INDESIT company

Model type:
AD1000EX

Commercial code:
F027764

Notices

FIG. 1

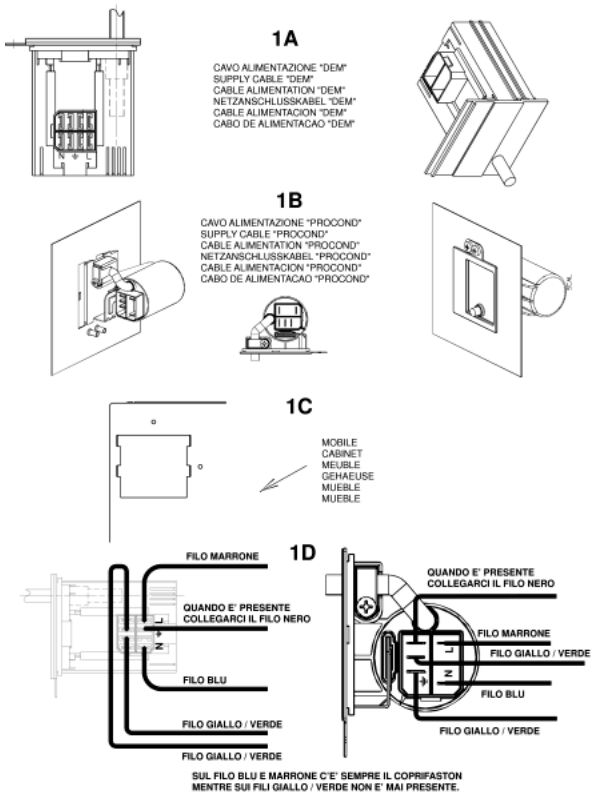
n1040276: Power supply cable + integrally moulded filter.

All appliances produced in the Comunanza (from serial no. 21008.0001), Teverola (from serial no. 21111.0001) and Brembate (from serial no. 21119.0001) factories have been equipped with power supply cables with integrally moulded filter (see fig.1 - 1A and 1B) and new units having a specific opening at the back for fixing the new cables (see fig. 1 - 1C).
The new units, together with the new cables, can be used in place of the premodification ones, by connecting the wiring to the cable, as shown in figure 1 - 1D.
The codes of the new units and of those replaced (ESI - table n1040276fig02), which will be managed until stocks run out, are given below.

IMPORTANT: the fixing / continuity screw is a specific self-scraping screw (code 092348) that ensures earth continuity between the filter and the unit. The same screw must be refitted in order to guarantee machine conformity.

The premodification wirings, are also managed for modified products by making the connection to the terminal block of the new cable as shown in fig. 1 - 1D.
The wiring diagrams given in the Documentation remain unchanged.

The new power supply cables are:
Code 091632 - Power supply cable 3x1 schuko 1.5m+capacitance filter;
Code 091633 - Power supply cable 3x1 schuko 1.5m+inductive filter;
Code 091634 - Power supply cable UK 3x1 l= 1950mm + inductive filter;
Code 091635 - Power supply cable UK 3x1 l=1950mm+capacitance filter;
Code 091636 - Power supply cable l=2.55m AUS+inductive filter;
Code 091641 - Power supply cable l=2550mm AG +capacitance filter;
Code 091642 - Power supply cable 1.85mt SHUKO no inductive filter;
Code 091643 - Power supply cable 3x1 (CH) 1.5m+inductive filter;
Code 091645 - Power supply cable 3450mm SOUTH AF.+capacitance filter;
Code 091690 - Power supply cable shuko l2.55m KOREA+inductive filter;
Code 091689 - Power Supply cable l=2550mm AG+inductive filter.

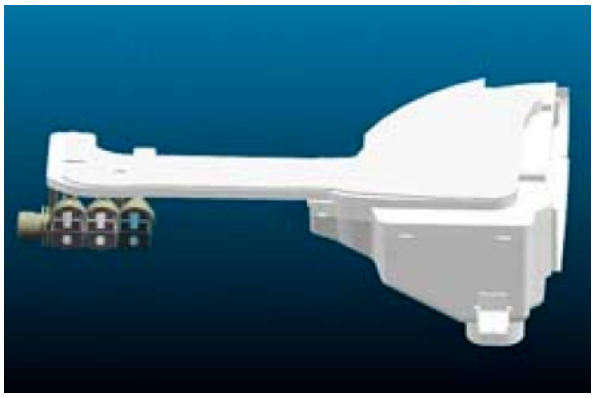
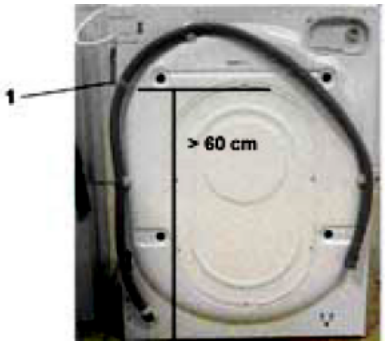
n1040282: New drainage OKO system.

From serial number 21219.0001, the new "OKO" drainage system has been introduced on the washing machines produced in the Comunanza factory.

- EEPROM (the OKO system requires a new setting of load timing parameters). THE NEW EEPROMS REPLACE ALL THE ONES CODED PREVIOUSLY.
- BOWL (hopper tube hole shifted forwards);
- DETERGENT LOADING TUBE (see fig. 1);
- PRESSURE SWITCH (changed levels);
- OKO PUMP BOWL BLOWER + BALL (see fig. 2A, 2B and 2C);
- CONDUCTIVITY SENSOR (if provided, it is shorter than the premodification item);
- DRAIN PUMP (without detergent collecting tube connection);
- HOPPER (shifted in front of detergent loading tube connection). Fig. 3A post-modification. Fig. 3B premodification);
- AIR TRAP (different shape);
- PRESSURE SWITCH TUBE (different length);
- DRAIN TUBE STOP (specific);

In particular, the OKO system consists of a spherical plastic component inserted in the tube that connects the bowl to the drain pump (see fig.2 A).
At the beginning of each wash cycle the washing machine fills water for 10 seconds and activates the drain pump for 2 seconds. In this way, the water level in the bowl is different from that in the drain tube; this difference increases the thrust of the ball upwards, closing the bowl-pump connection tube hermetically (see fig. 2D).
This system has the double advantage of:

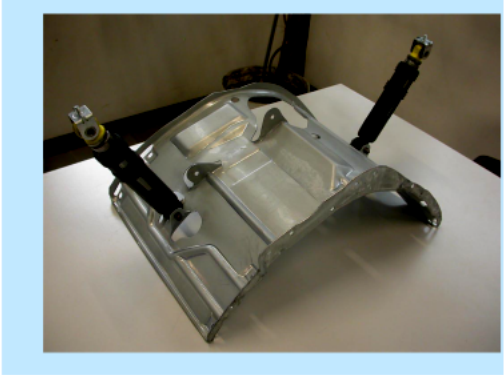
n1040325: New shock absorber fixing system with pin

From serial no. 40427.0001, shock absorbers have been fixed to the tank unit cradle with two 11 mm pins code C00110163 (see fig. 01 and 02 enclosed) in place of the 8 mm screws code 093750 and relevant locking nuts code 030443, on all washing machines and dryers produced in the Comunanza factory.
The items affected by this modification are:

To remove the shock absorber from the tank, first extract the pin with a few hammer taps (see fig.03) until it is aligned with the tank bracket and then pull it out with a pair of pliers (see fig. 04).
(To refit the shock absorber use a new pin. Insert the pin until the toroidal edge is aligned with the bracket.)

1) The cradles have the same Service code, as they can be used in place of the new ones after widening the shock absorber fixing holes to a diameter of 10 mm.
Code 093848 - Tank unit cradle 46 lt
Code 093878 - Tank unit cradle 40 lt.

2) The new shock absorbers, with fixing bushing having no s/steel spacer, are not managed as they are interchangeable with the premodified items (make sure they are CIMA type, as the managed items), fixed with M8 screws code 093750 and related locking nut code 030443 (see figs. 05 and 06).
Code 093884 - Shock absorber 80 N
Code 093885 - Shock absorber 100 N

Fig . 001

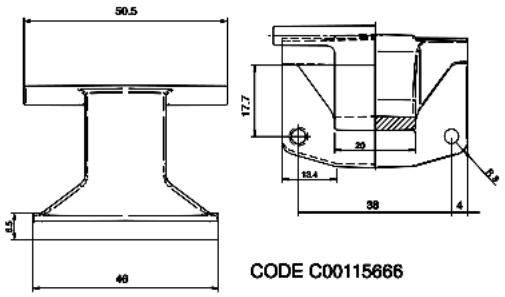
n1040349: Introduction of 150° Zamac hinge on Ariston 46 models.

From serial no. 50207.0001, all Ariston models produced in the Teverola factory (see table 001 attached) with industrial code (given on the rating plate) starting with 46, have been equipped with a Zamac hinge with 150° opening angle, code C00115666

(see Fig.001).
This modification has involved the introduction of the following items:

Code C00115670 - Complete door EVOII 150° white 27 with standard glass;
Code C00115674 - Complete door EVOII 150° white 27 with long glass;
Code C00115667 - EVOII body for 150° hinge white 27;

The premodified items are not interchangeable separately with the modified ones.
